Access Compliance Report

Public Rights-of-Way

(Curb Ramps)

Intersection ID: 45514	Main Street: MEADOW_BOTTOM_RD	Cross Street: COTTON_PRESS_RD	Location: S
ADA ID: 07BBED4A57D2	Ramp Type: PerpDiag	Initial Pass/Fail: Fail	Overall Compliance: No
Severity Score: 31.25			
Codes/Mitigation Info/Possible Solution		Field Measurements/Component Compliance

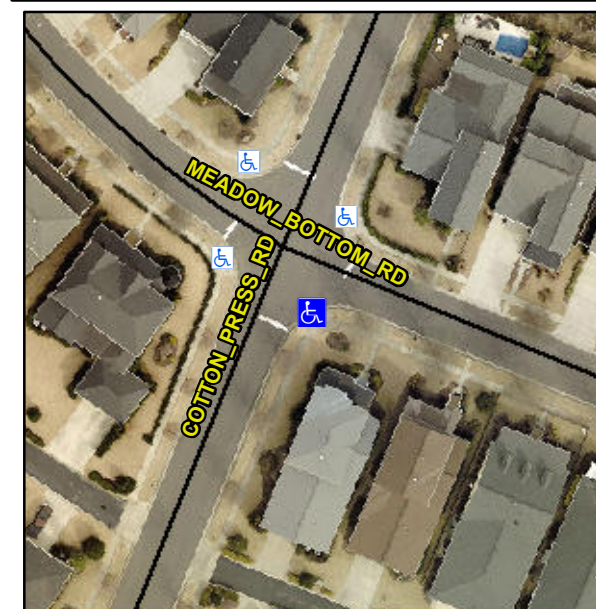
Not Found, R304.5.1, R304.2.2, R304.5.3

Compliance	Description	Data	Compliance	Description	Data
N/A	Ramp Length (in)	72.0	No	Ramp Slope (%)	11.3
No	Ramp Width (in)	33.0	No	Ramp XSlope (%)	2.6
N/A	Flare Type LT	N/A	N/A	Flare Type RT	N/A
N/A	Flare Slope LT (%)	N/A	N/A	Flare Slope RT (%)	N/A
N/A	Flare Traversable LT?	N/A	N/A	Flare Traversable RT?	N/A
N/A	Landing Length (in)	N/A	N/A	DWS Provided?	N/A
N/A	Landing Width (in)	N/A	N/A	DWS Contrast?	N/A
N/A	Landing Slope (%)	N/A	N/A	DWS Length (in)	N/A
N/A	Landing X Slope (%)	N/A	N/A	DWS Full Width?	N/A
N/A	Landing Curb? (Y/N)	N/A	N/A	DWS Offset (in)	N/A
N/A	Shared Landing?	N/A			
N/A	Gutter Ponding?	N/A	N/A	Gutter Slope (%)	N/A
N/A	Gutter Lip Ht (in)	N/A	N/A	Gutter X Slope (%)	N/A
N/A	Painted X Walk1?	No	N/A	Painted X Walk2?	No
	X Walk 1 Direction	To NE		X Walk 2 Direction	To NW
N/A	X Walk 1 Width (in)	N/A	N/A	X Walk 2 Width (in)	N/A
	X Walk 1 Slope (%)	0.2		X Walk 2 Slope (%)	3.3
	X Walk 1 X Slope (%)	0.9		X Walk 2 X Slope (%)	0.4

Remove & Replace Curb Ramp With Two New Directional Ramps or Equivalent.
